ADDENDUM

PROJECT NAME: Henry Puffer Playground Improvements
CLIENT: Downers Grove Grade School District 58
WIGHT PROJECT NO.: 220286
DATE / TIME: 04/24/2024 / 5:00 PM
TO: Interested Bidders
FROM: Lara Barnas, Wight & Company

ADDENDUM NO. 1

This ADDENDUM consists of ONE (1) Addendum description sheet and THREE (3) plan sheets. This ADDENDUM shall be attached to and form a part of the Contract Documents. This ADDENDUM is being issued to reflect changes resulting from product selection change.

GRADING AND DRAINAGE PLAN

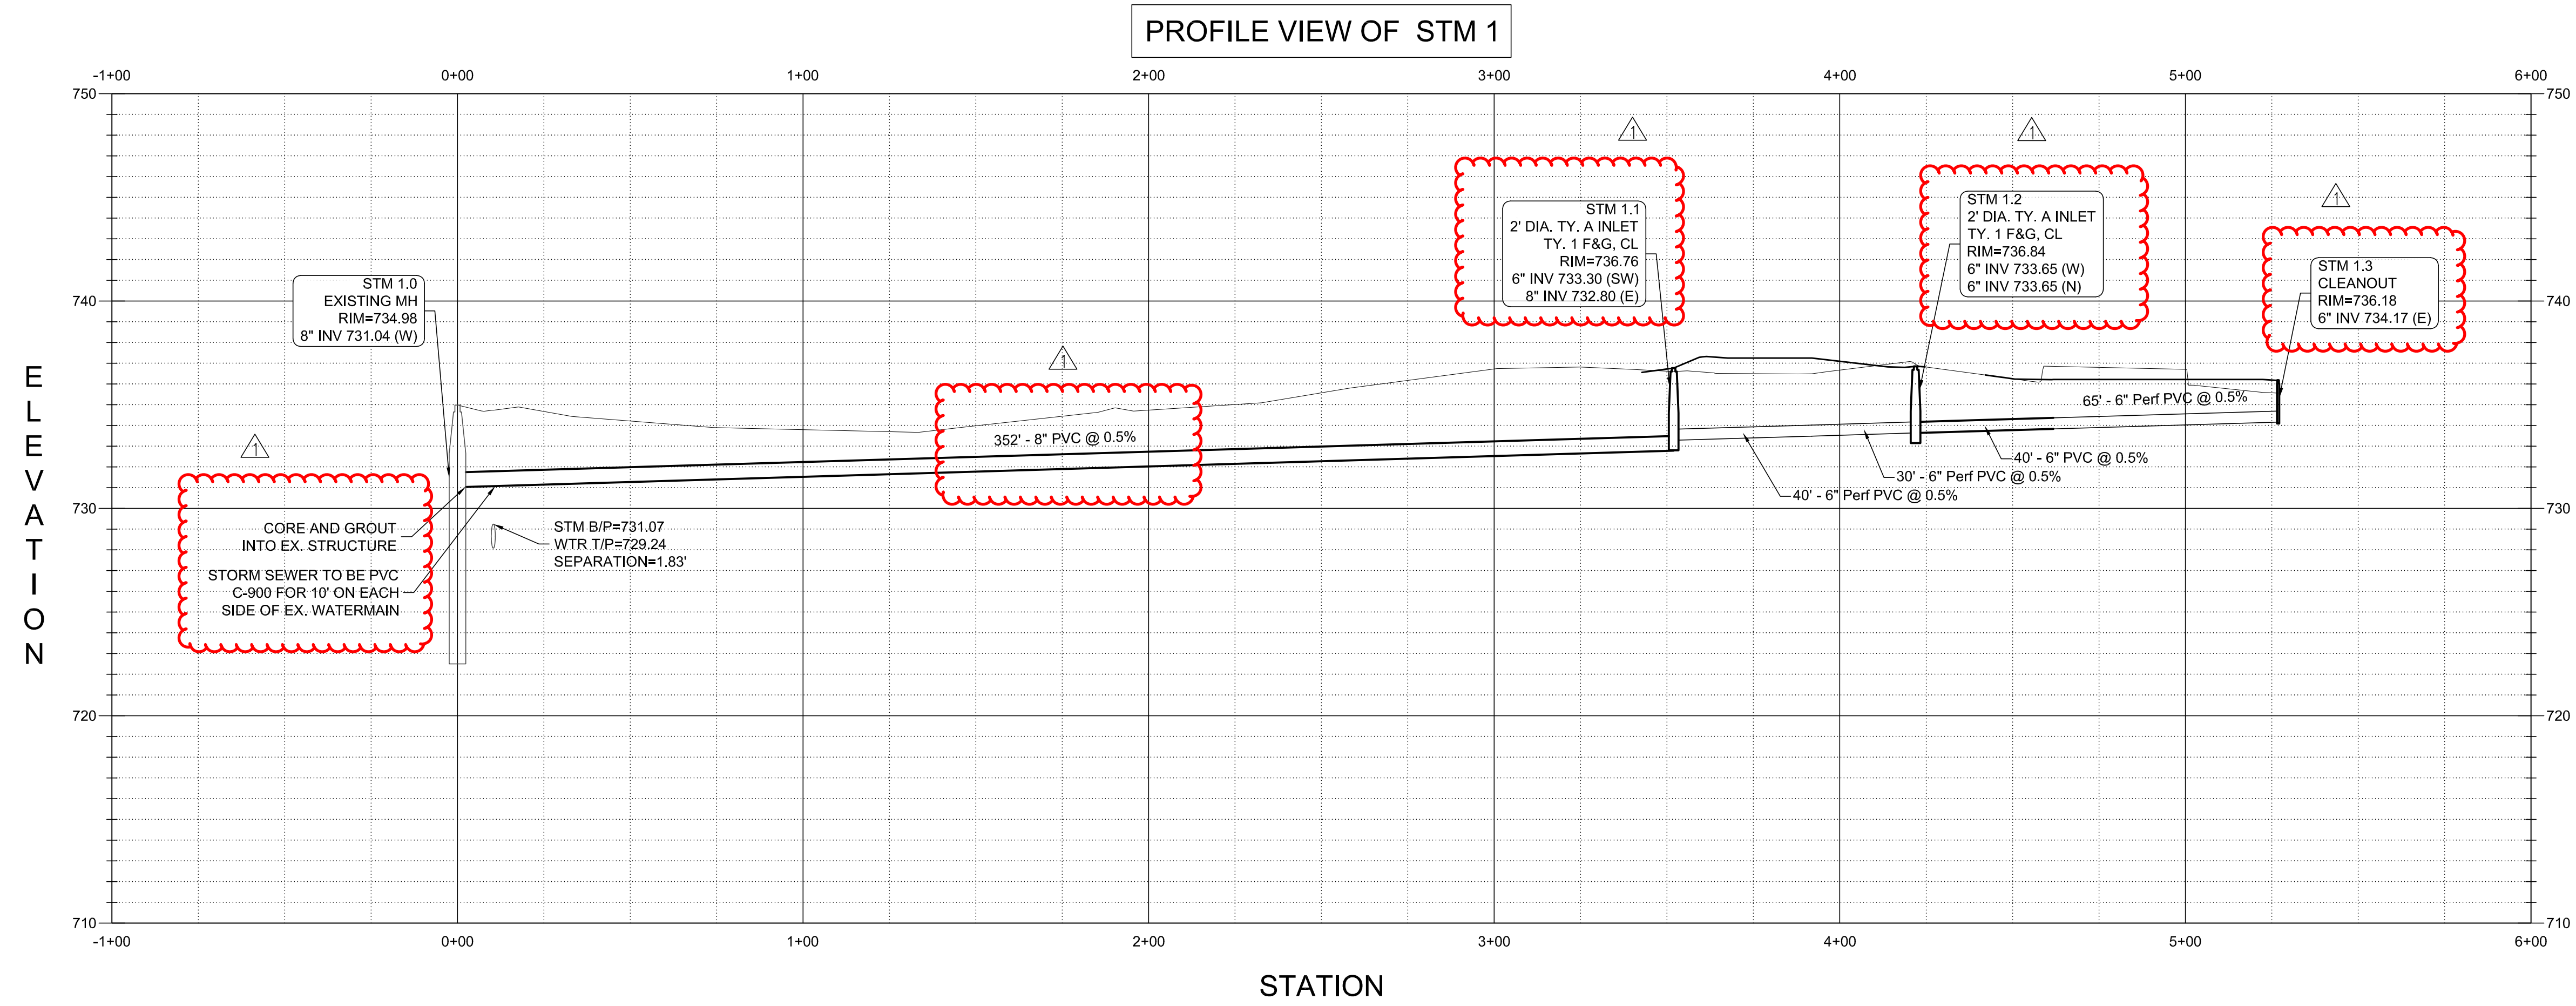
1. Sheet C3.00 – Grading and Drainage Plan
 - a. **MODIFIED storm sewer size from 12" to 8"**
2. Sheet C3.01 Utility Profile Plan
 - a. **Connection note and watermain protection note have been ADDED. Storm sewer size MODIFIED from 12" to 8". STM 1.1 and STM 1.2 have been MODIFIED to 2' diameter type A inlets.**
3. Sheet C4.02 Details
 - a. **Detail 3 has been MODIFIED to a 2' diameter type A Inlet.**
